IN THE DRAWINGS

By separate letter to the draftsman, corrected drawings for Figures 6, 8, 10, 11, 13, 15, 17, 19, and 20 are submitted. The corrected drawings do not add new matter to the application. More specifically, the block labeled "frequency analyzer section 104" is added to each of Figure 6, 8, 10, 11, 13, 15, 17, 19, and 20 in conjunction with the sound source estimation section 116. As argued below, section 104 is described as being part of the sound source estimation section 116 shown in Figure 1, and, in fact, it is part of the aforementioned Figures. Therefore, the changes to these Figures do not introduce new matter into the specification.

FIG. 13

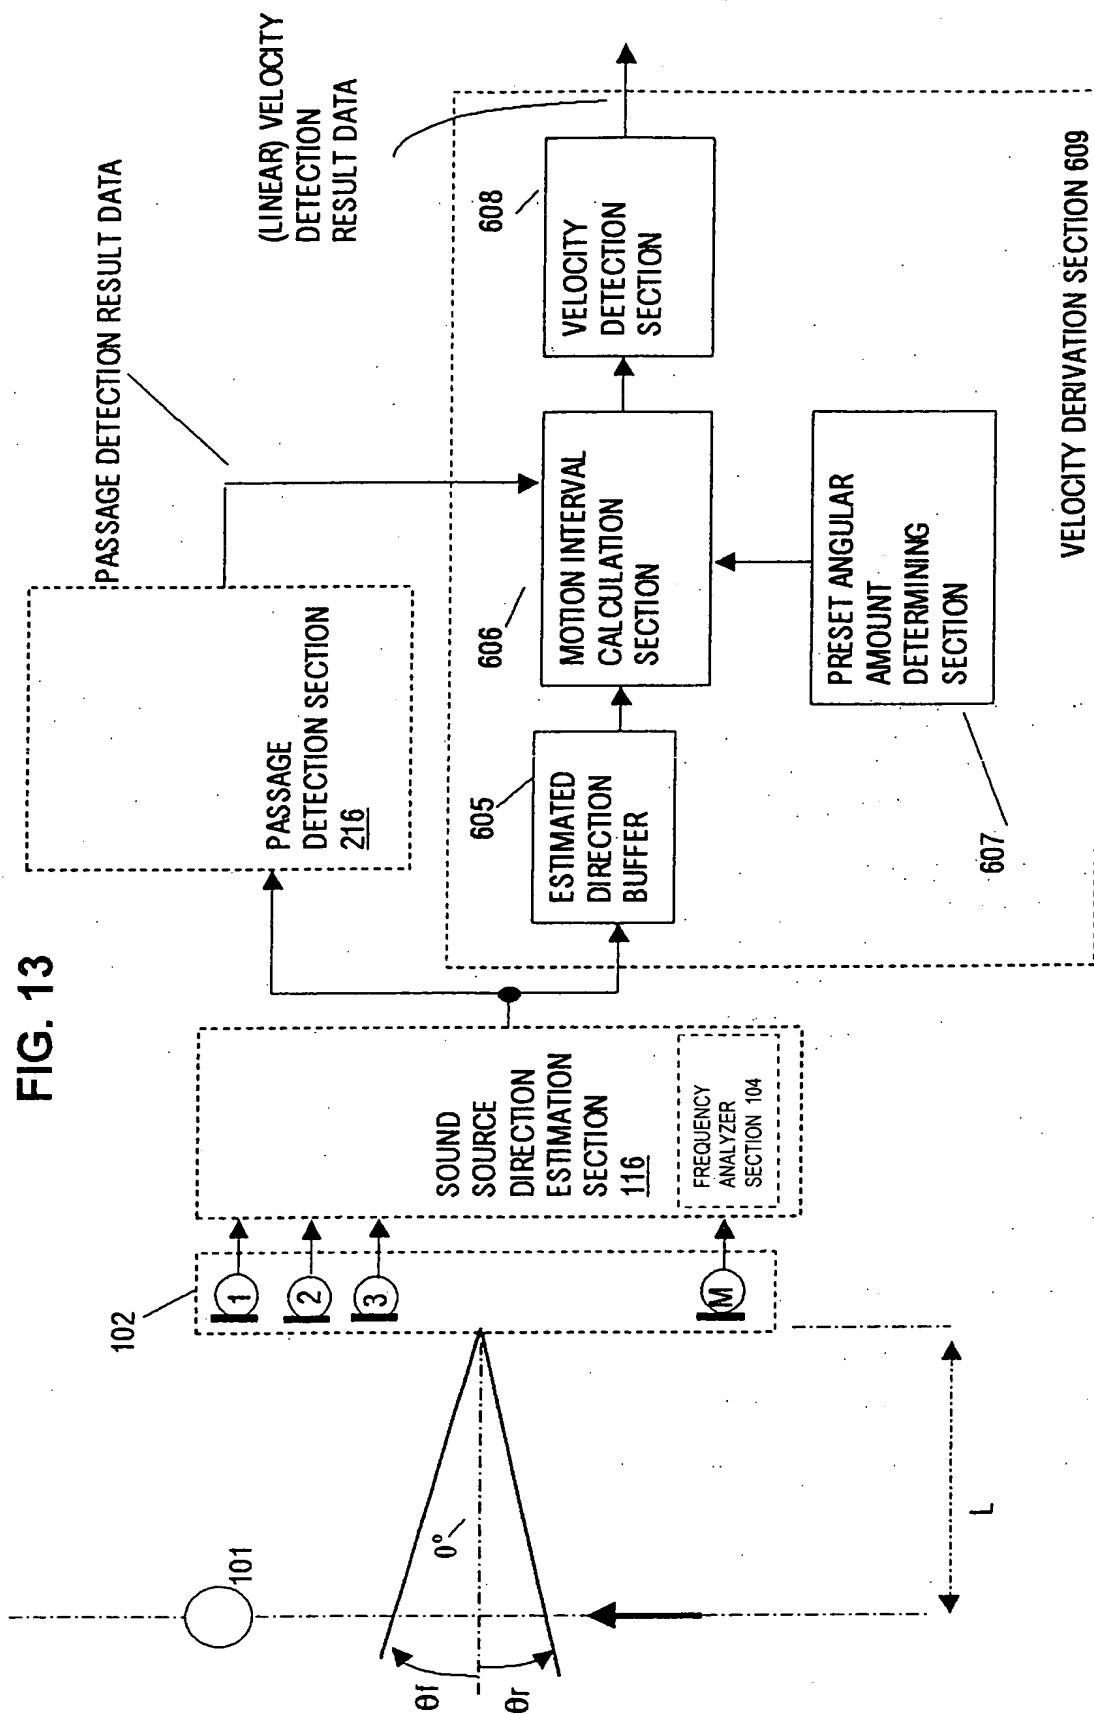
Applicants also question the objection to Species VI, and the allegation that the drawings do not depict a present angular amount determining section. Figure 13 of the drawings specifically identifies this claim feature as reference numeral 607, and the objection in this regard should be withdrawn.
